Stakeholder Comments Template

| Submitted by | Company | Date Submitted |
|---|------------------------|-------------------|
| Brian Theaker brian.theaker@nrg.com 530-295-3305 | NRG Energy, Inc. (NRG) | February 19, 2016 |

Please use this template to provide written comments on the Clean Energy and Pollution Reduction Act Senate Bill 350 Study initiative posted on February 4, 2016.

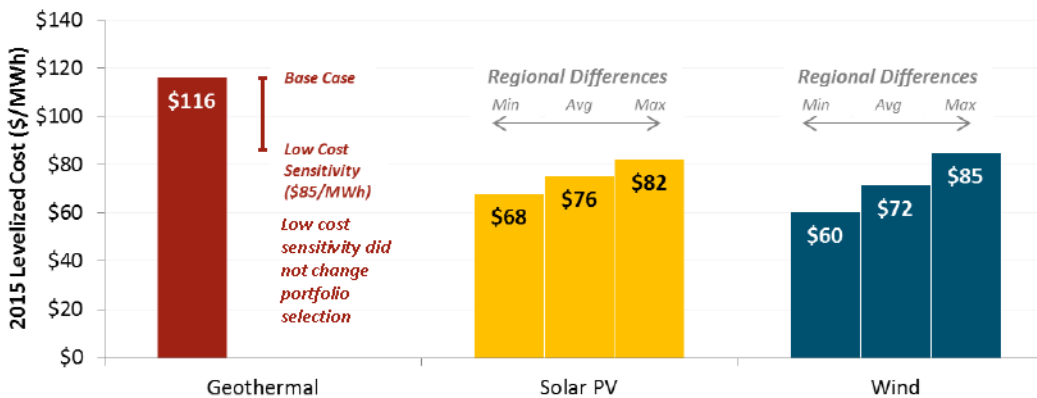
- What assumptions will be made about how TOU rates may or will encourage in-state mid-day consumption, making it less necessary to dump surplus mid-day solar to other states?
- The studies assume a net export value of up to 8,000 MW. It is difficult to assess the viability of this number with no historical basis for such a number

available. California’s ability to export its solar surplus to other states should not simply be assumed. Other states with excellent solar and wind resources may experience explosive growth in renewable deployment, and the ability to sink California solar surplus to those states should not be taken as a given.
